**NORTH & SOUTH SEAWALL at WEBHANNET DRIVE  
WELLS, MAINE  
D&K Project No. 627789P5**

**ADDENDUM NO. 1**

July 17, 2023

**RIPRAP DETAIL**  
SCALE: 1" = 1'-0"  
(GEOMETRY OF WALL IS UNKNOWN)

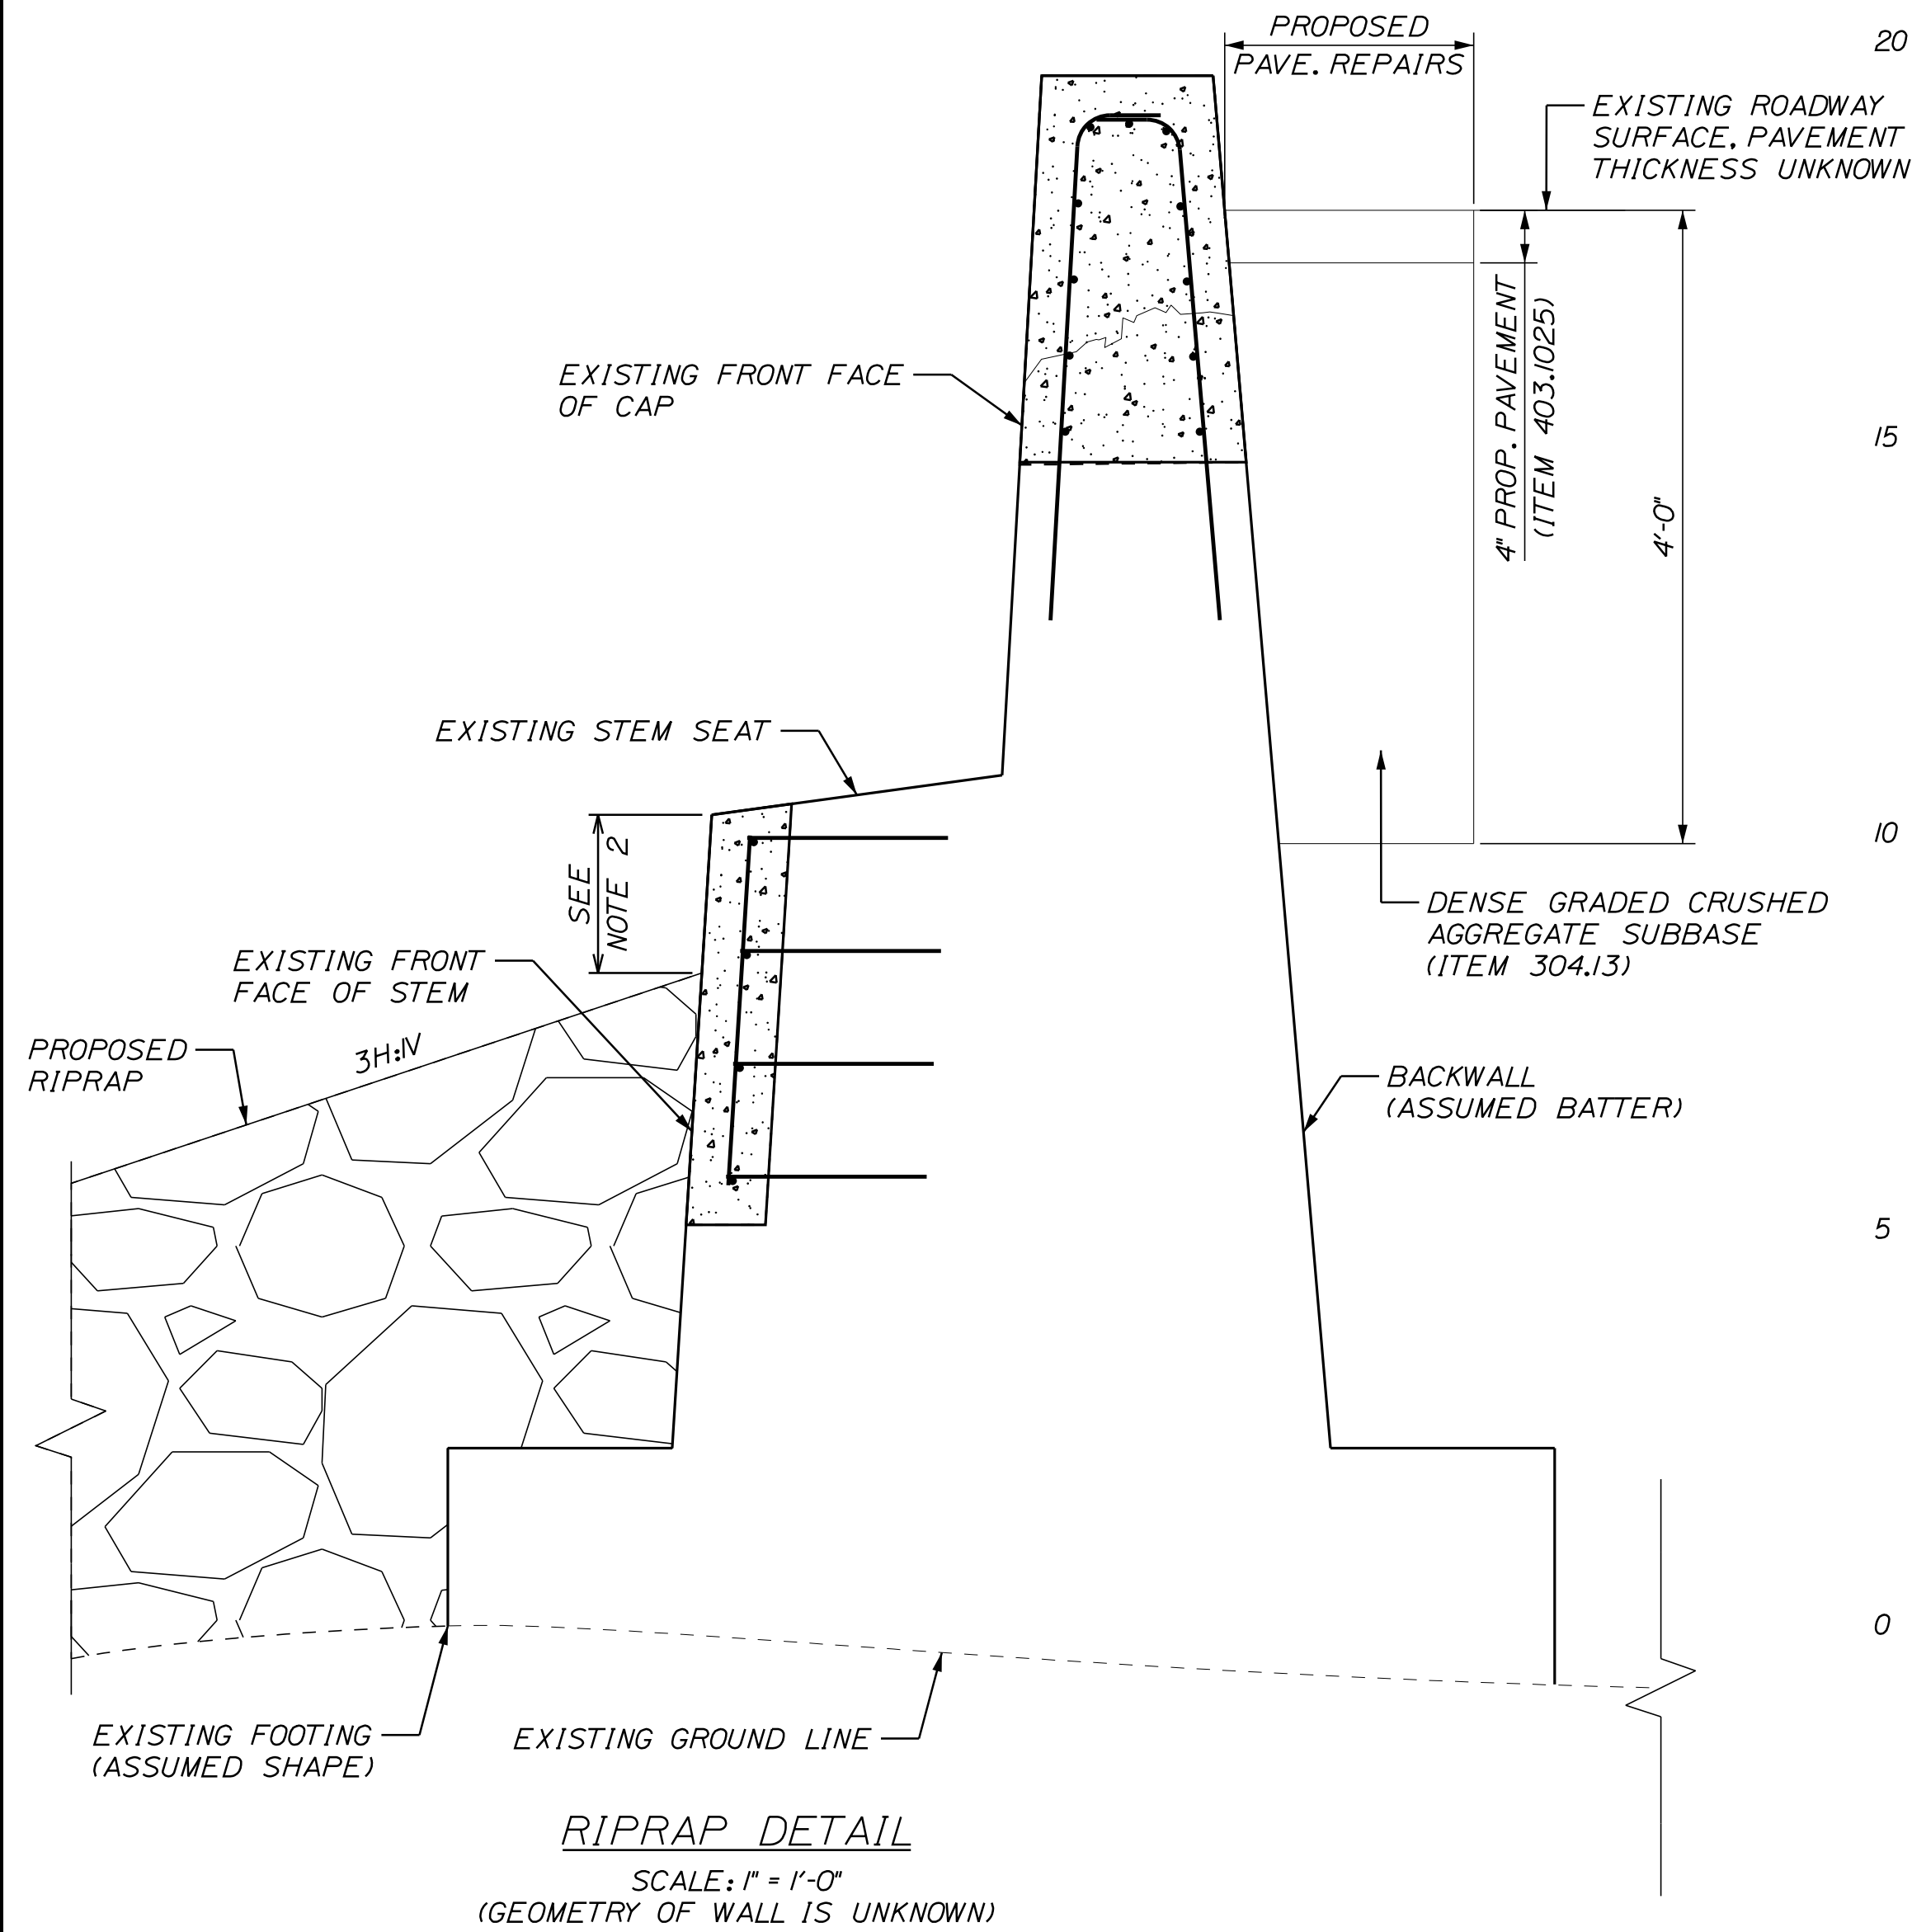
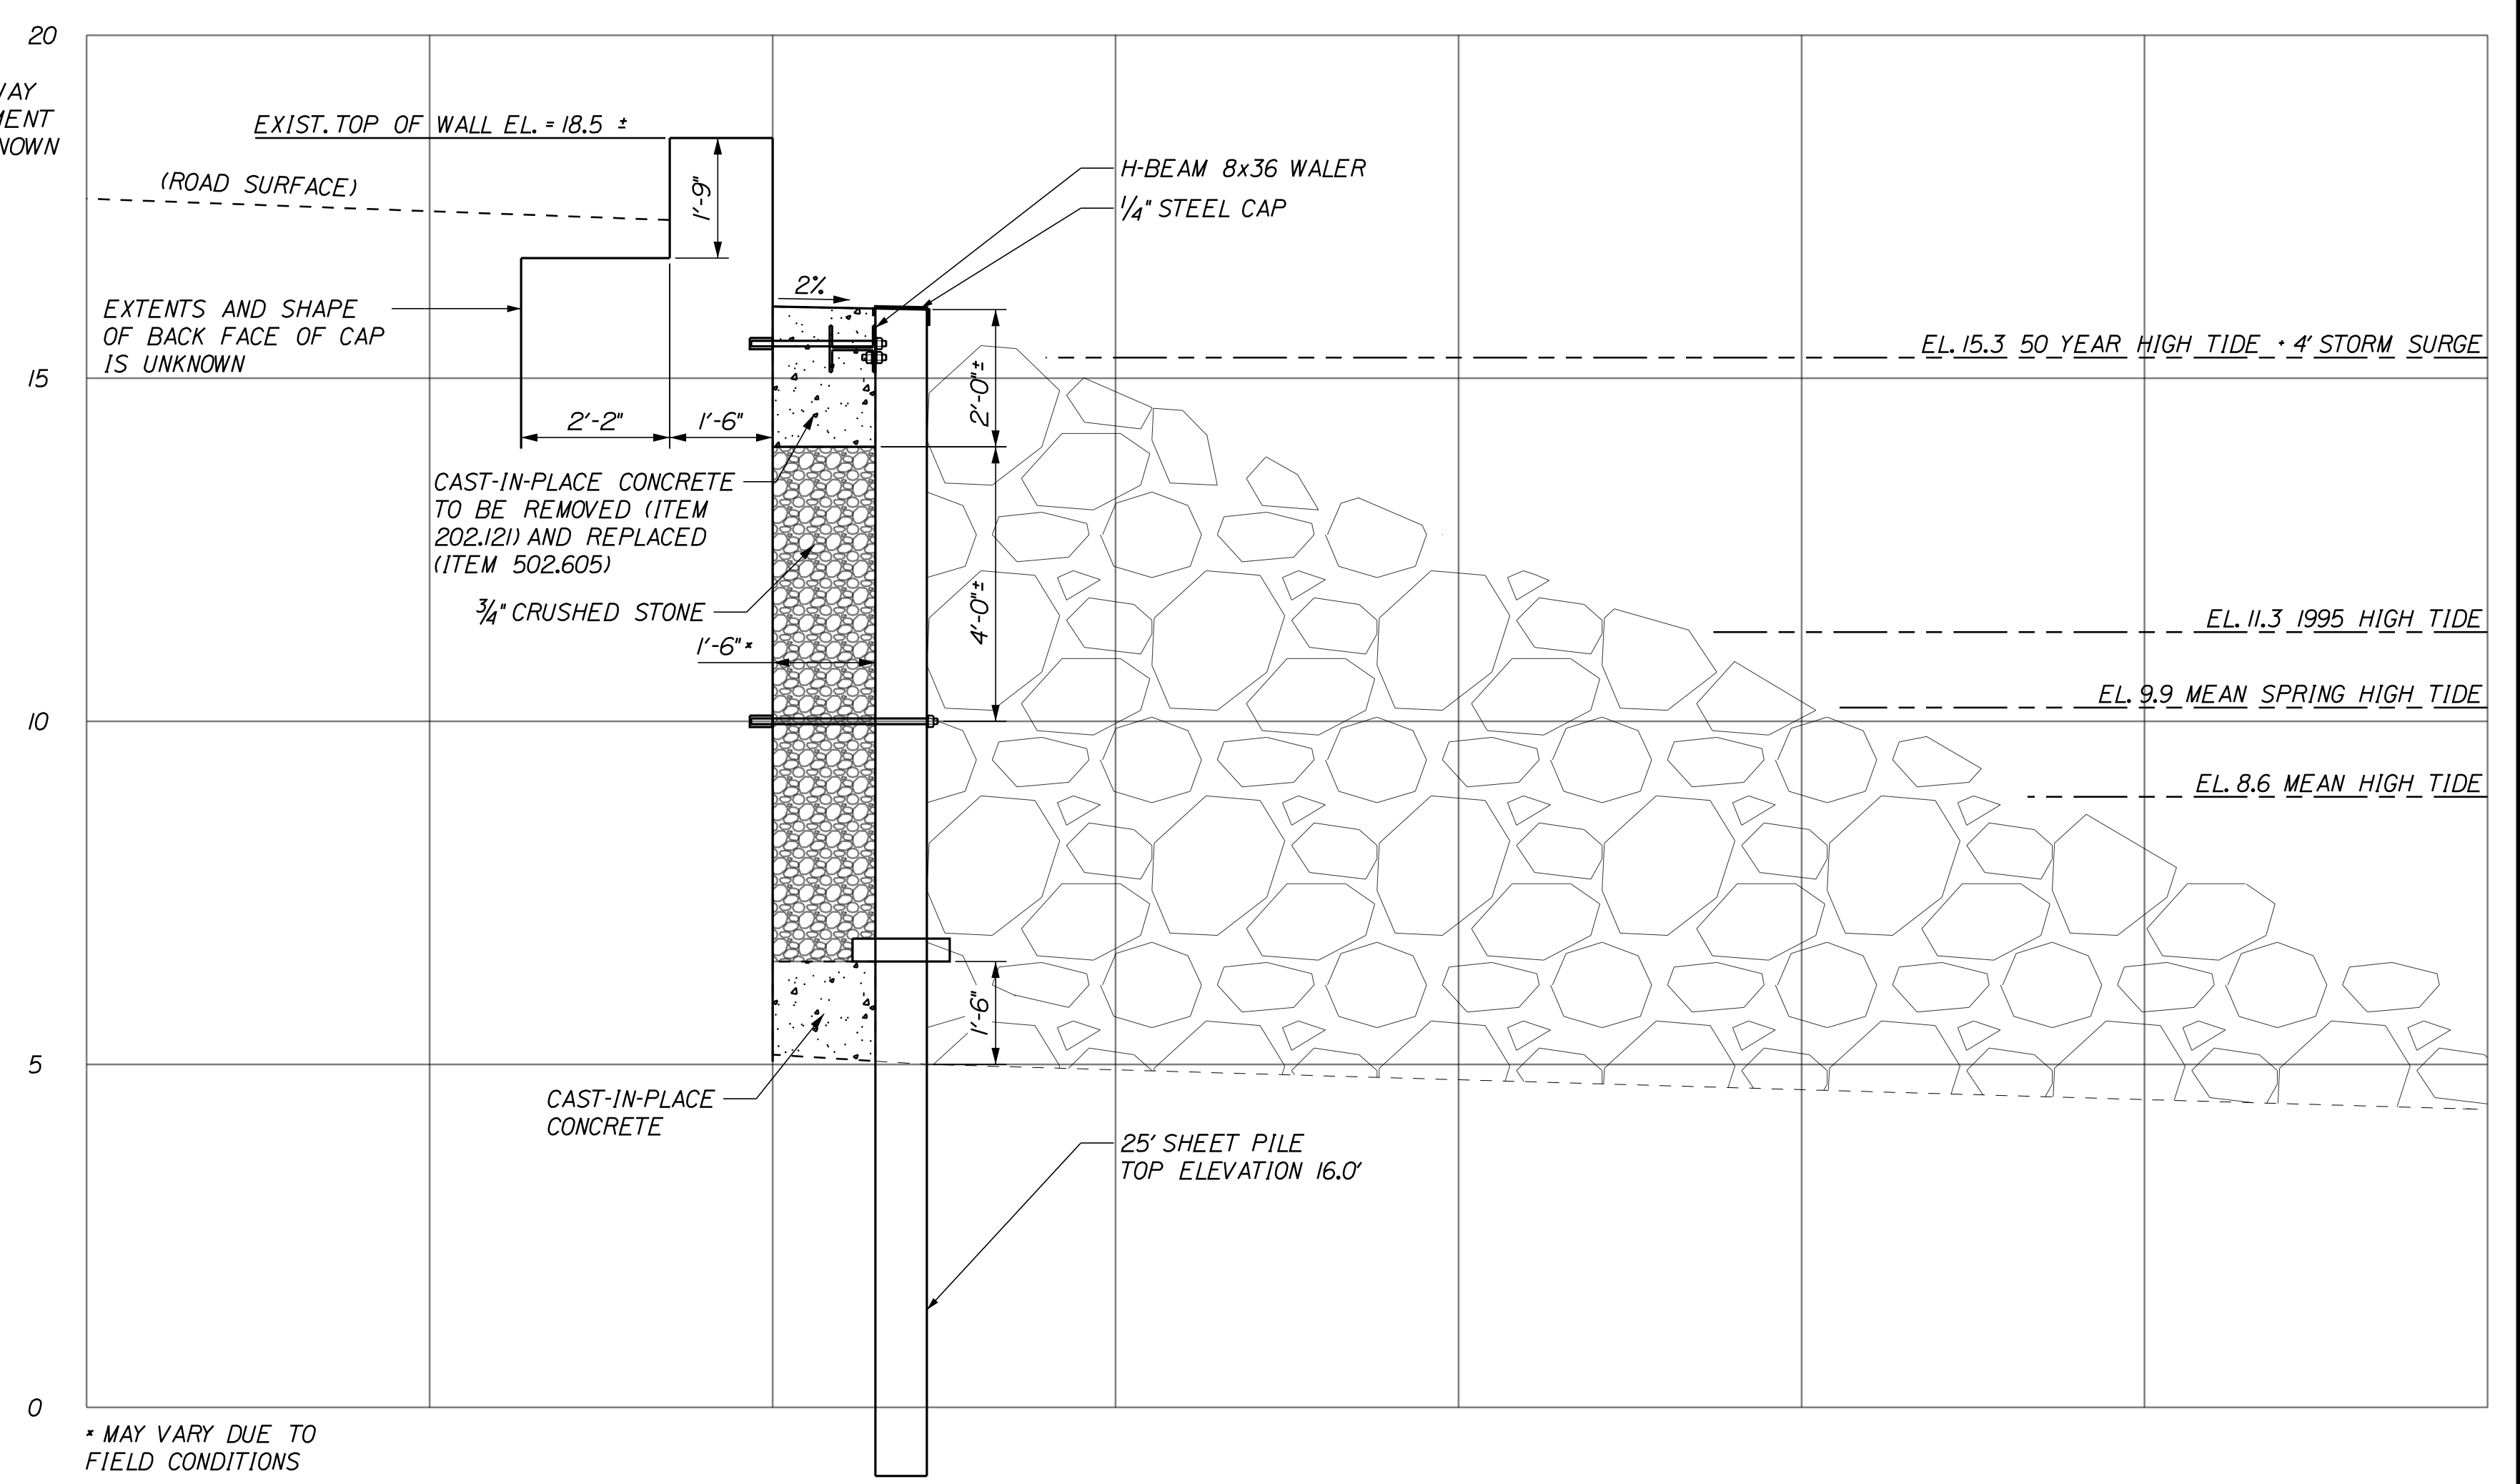
Q7) What are the limits of the rip rap work?

A) See notes 1-3 on sheet 15 of the plans. All riprap shall be placed in an interlocking pattern along the full length of both walls at an approximate 3H:1V ratio. At the North wall riprap shall be placed to

be a minimum of 1'-0" and maximum of 3'-0" below the existing stem seat (see Riprap detail sheet 15). At the south seawall riprap shall be place a minimum of 4'-0" above the 50 year maximum high tide elevation (see South Wall Typical Cross Section, sheet 15).
